Re: ICC-ES Proposal AC516-1020-R3 "Factory Applied Fire-Retardant Penetrant for Wood Structural Panels and Sawn Lumber"

FRCT's Reply to the public comments for October 6th and 7th, 2020 ICC-ES Evaluation Committee hearing.

Subject: Proposed New Acceptance Criteria for Factory Applied Fire-Retardant Penetrant for Wood Structural Panels and Sawn Lumber, Subject AC516-1020-R3

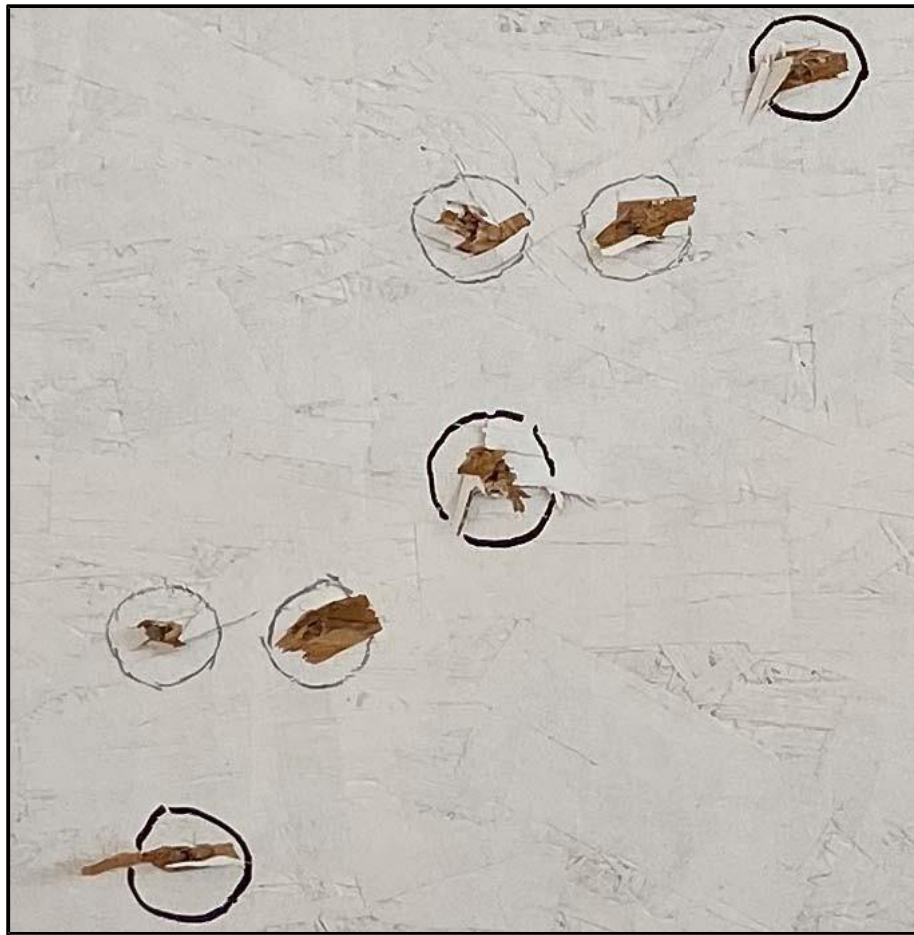
Shallow and micro-penetration has similar concerns as that of coated products. A protective layer at the surface of a material is obviously not inherently protected and available deep within the substrate as found with conventional FRTW.

In the case of exterior wall and roof sheathing applications, nails installed nearly always result in some amount of surface delamination. This delamination may remove most, if not all of the protective chemical, leaving untreated wood exposed to heat and flame. This obviously will have some impact on the rate of surface burning propagation and must be evaluated to determine equivalence.

The AC516 criteria clearly identifies the chemical as a fire-retardant penetrant, that is permanent. AC516 has the required testing of wood structural panels be tested with untreated joint and roofing nails placed in the panels after treatment, along with a 1/8-inch saw cut down the length of the panels after treatment. End of Comment

The representation in the photo is NOT an example of a fire-retardant application. It is misleading because it is a “coating”. Criteria requirement for intumescent coatings applied to wood can be reviewed in the AC479. In addition, unlike the AC66 or AC479, Section 3.2 of the AC516 addresses any concern by providing requirements for 1/8” sawn gaps and grooves cut after treatment. These gaps are designed to demonstrate adequate surface burning performance with minor surface damage. We will add the nail placement back into AC516. [End of Comment](#)
